Overview: Production error in version 1.0 harnesses; The immobilizer wire (orange/black) is in pin position #4 instead of pin position #5. Although an effort to correct the issue was made, some quantity of harnesses did get shipped before the issue was spotted. We are advising to inspect the harness BLADE connector before attempting to install harness or program the module. This issue is not known to affect the version 2 harnesses, which require no modification.

MODIFICACIÓN REQUERIDA PARA APLICACIONES A/T, SÓLO CON ARNÉS v 1.0

FTI-STP1: Notas de preparación y cobertura del vehículo

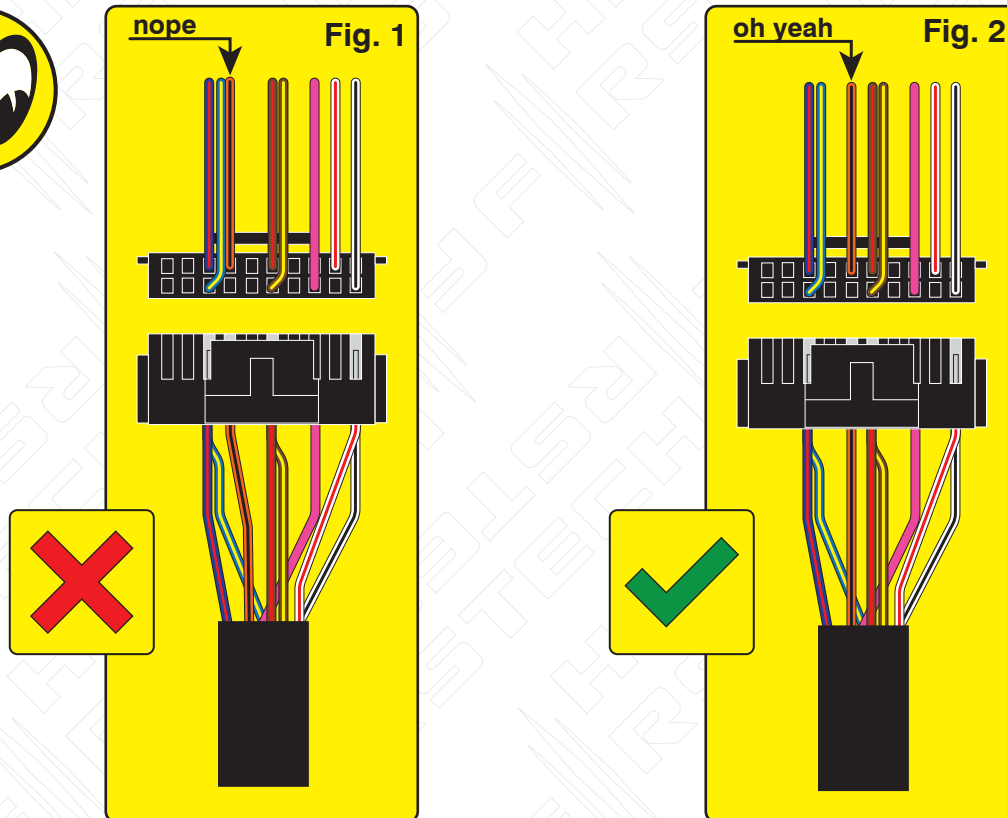
Issue: Module fails to program correctly to vehicle, does not allow the vehicle to be remote started.

Correction: Step 1.) Locate the orange/black wire and confirm whether it is positioned as illustrated in Fig. 1 or Fig. 2. If the wire is as illustrated in Fig.1, proceed with Step 2 through 5 and complete the repair procedure outlined, if the wire is as illustrated in Fig. 2, correction is not necessary, proceed with harness installation and module programming.

Step 2.) Using a pick, lightly depress the catch that secures the terminal in the housing then remove the wire and terminal from the housing.

Step 3.) Using a fine tip razor or utility knife, insert the blade beneath the terminal catch and raise it slightly, so that it can be reused to secure the terminal when reinserted into the BLADE connector housing.

Step 4.) Refer to Fig. 2 for correct position of the orange/black wire (next to brown/red) then reinsert the terminal, pressing lightly until the catch 'snaps' into place, securing the terminal in the connector housing.

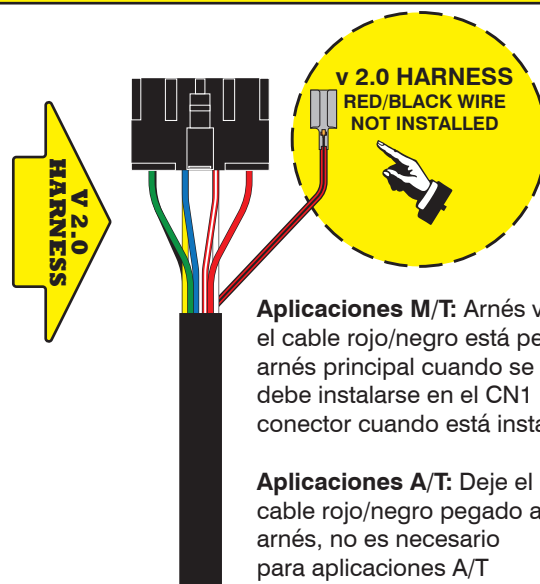
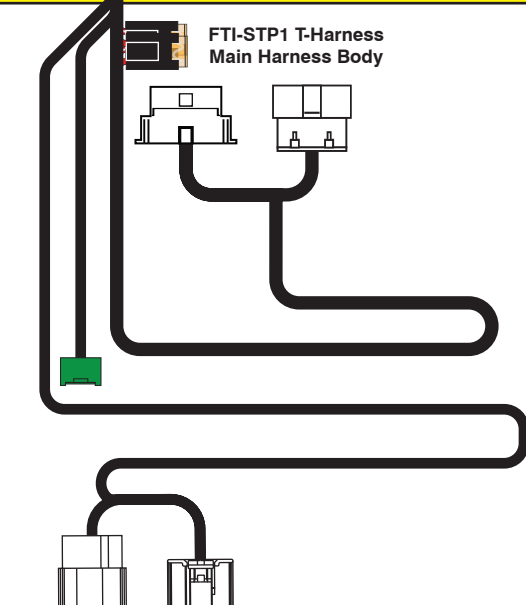
Problema: El arnés en T FTI-STP1 ha sido diseñado para ser compatible con A/T (transmisión automática) y M/T (manual), pero debido a un descuido en las primeras ejecuciones de producción, la selección se estableció por defecto en el modo M/T.

El uso de un arnés configurado para una aplicación M/T, en un vehículo equipado con A/T, podría provocar daños en el módulo del vehículo, se recomienda que el arnés vuelva al modo A/T antes de la instalación en vehículos equipados con transmisión automática.

Corrección: Localice el cable rojo/negro (+ embrague) proporcionado en el conector CN1 del conjunto del arnés principal. Corte el cable rojo/negro, ya sea al ras del conector CN1 o dejando suficiente cable expuesto para que pueda aislar y asegure los extremos del cable que quedan después del corte. Aísle cada uno de los extremos restantes del cable rojo/negro y asegúrelos para evitar cualquier posibilidad de cortocircuito. Si el cable rojo/negro ya ha sido desconectado, ninguna modificación adicional se requiere para aplicaciones A/T

NO SE REQUIERE MODIFICACIÓN CUANDO SE UTILIZA FTI-STP1 (v 1.0) ARNÉS EN APLICACIONES M/T, O CUANDO UTILICE EL ARNÉS FTI-STP1 (v 2.0)
